# PLAN OF SUBDIVISION

<b>Owners</b>	BASS CORPORATION PTY LTD	<b>Address</b>	Chapple Street, Ravenswood	This plan has been prepared only for the purpose of obtaining preliminary subdivision approval from the Council and the information shown hereon should be used for no other purpose. All measurements and areas are subject to final survey.
<b>Title References</b>	F.R. 46272/1	<b>Council</b>	Launceston City Council	
		<b>Planning Scheme</b>	Launceston Interim Planning Scheme 2015	
		<b>Zone &amp; Overlay</b>	10.0 General Residential	
<b>Scale</b>	1:1000	<b>Date</b>	10 January 2020	
		<b>PDA Reference</b>	44334-P07	
		<b>PID</b>	6916554

**RE: SUBDIVISION – SEYMOUR STREET, RAVENSWOOD**

# PLAN OF SUBDIVISION

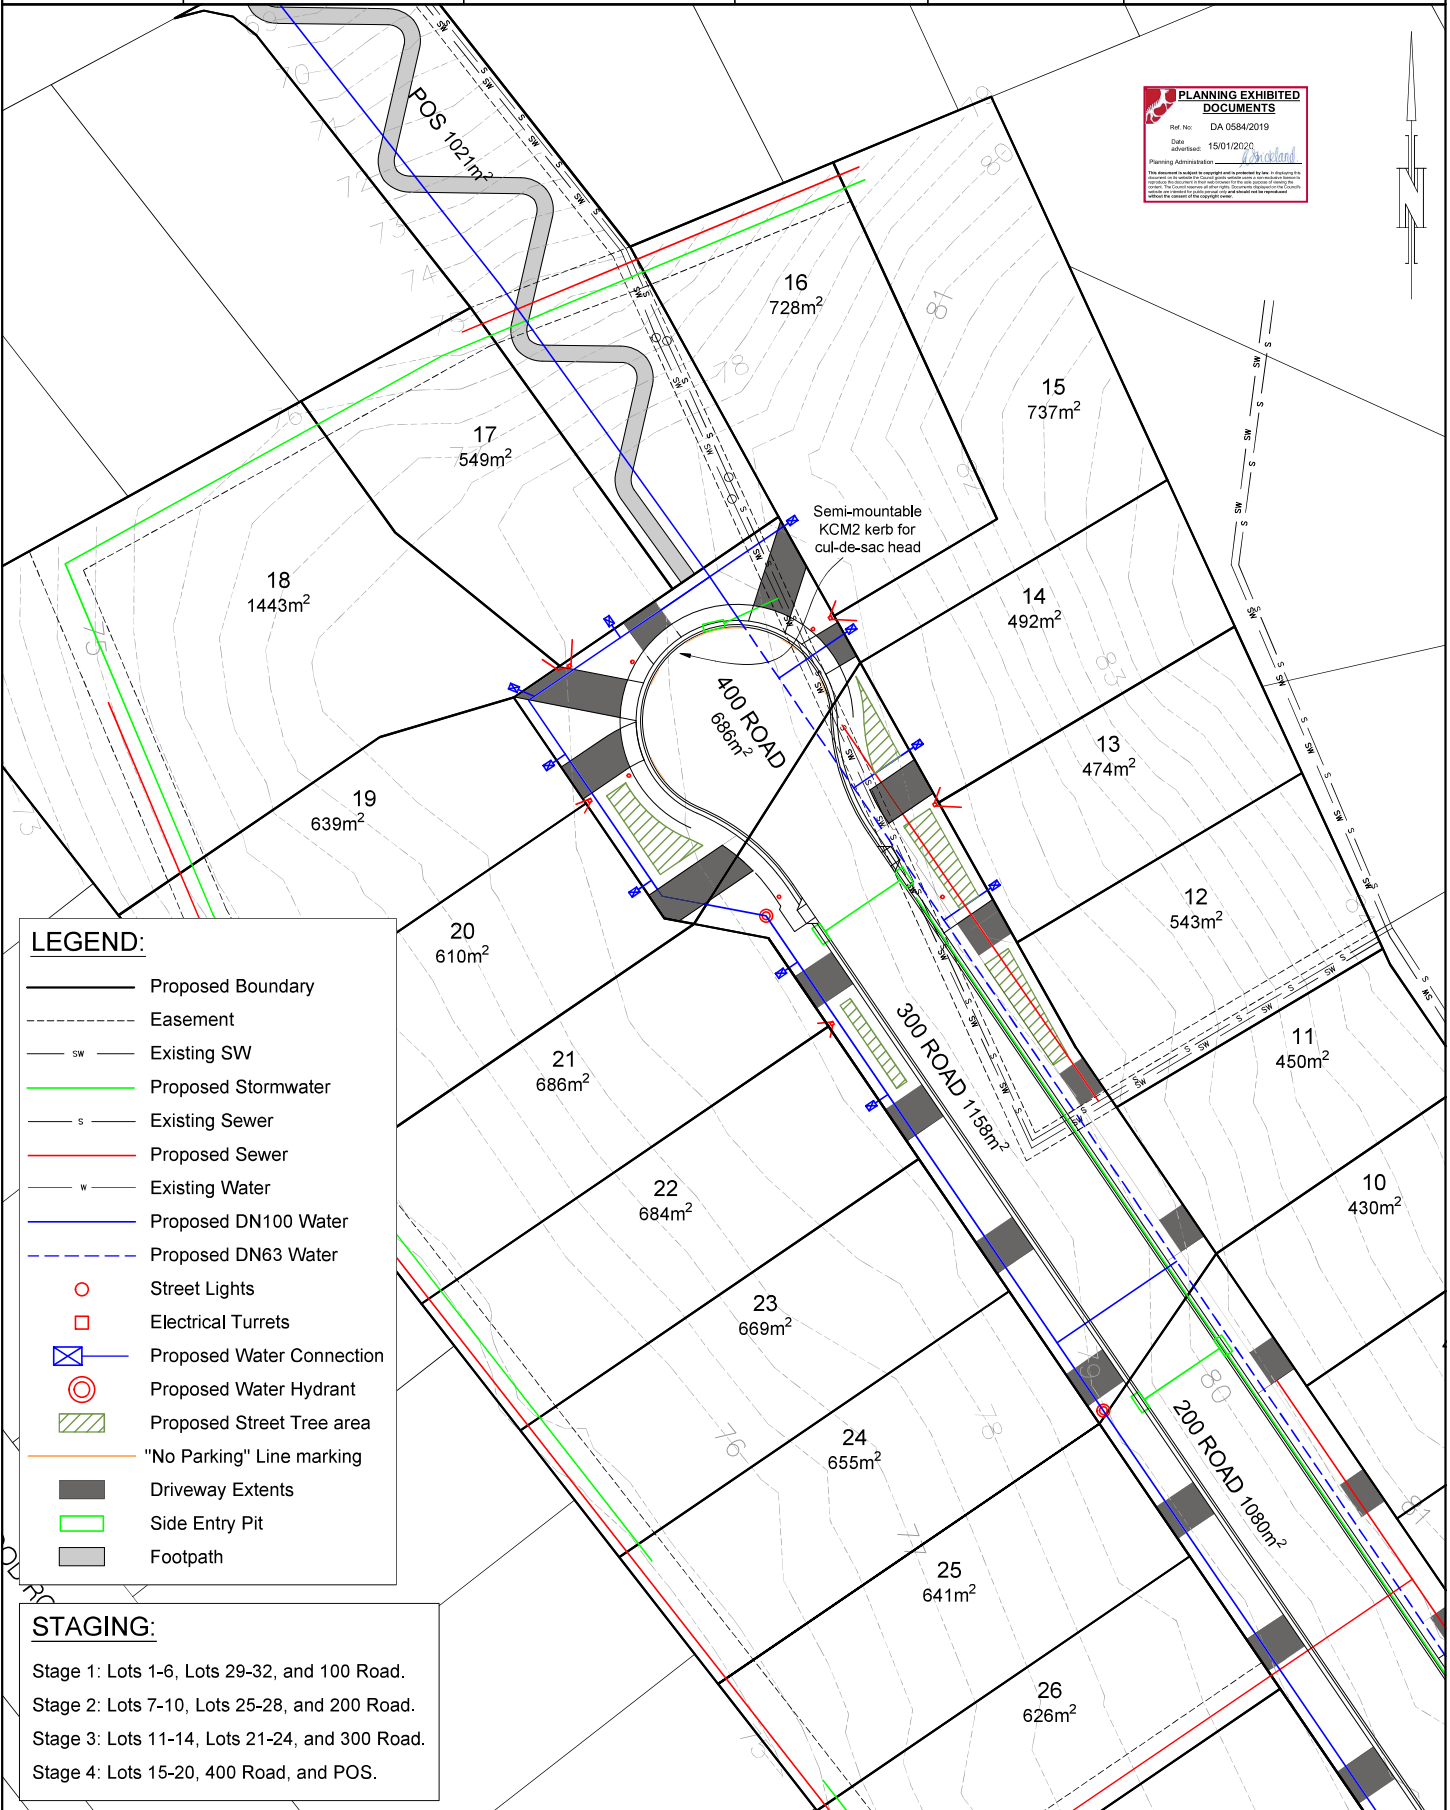
We believe we have already provided this information with our original application. The location of the proposal is shown on the plans and in the completed da form and by the provision of the title. The full description of the proposal is on the da form but is now, with changes made, the subdivision of 33 lots and road and open space in 4 stages.

We attach an amended proposal plan that has many of the lots over 500m<sup>2</sup> in size. Los 2 to 11 and lots 13 and 14 are just under 500m<sup>2</sup> in size. These lots because of the size and shape and location all meet the performance criteria and each lot contains a rectangle measuring 15m by 10m.

All lots have more than 3.6m frontage to a road. We also provide a concept servicing plan addressing the matters raised.

We have re arranged the indicative stormwater drainage system to reduce the flow through 23 Ravenswood Road.

We have amended the proposal plan as suggested by you to provide the whole width as open space.

We have reduced the number of lots on the plan. The lot sizes we have provided allow for a range of lot sizes to meet a wide range of purchaser requirements. The layout now meets the requirements of P1 and we cannot see a clause P2.

We have removed the lots that may have had some difficulty meeting this clause and the lots on the plan now meet P1 requirements.

We believe the open space lot on the plan meets part of the open space requirement. It provides link between two roads which is a requirement of clause 10.4.20. Given that there will be a condition from Council for a pathway to be constructed in the open space link at some considerable cost to the landowner we believe this should be considered as part of the open space contribution.
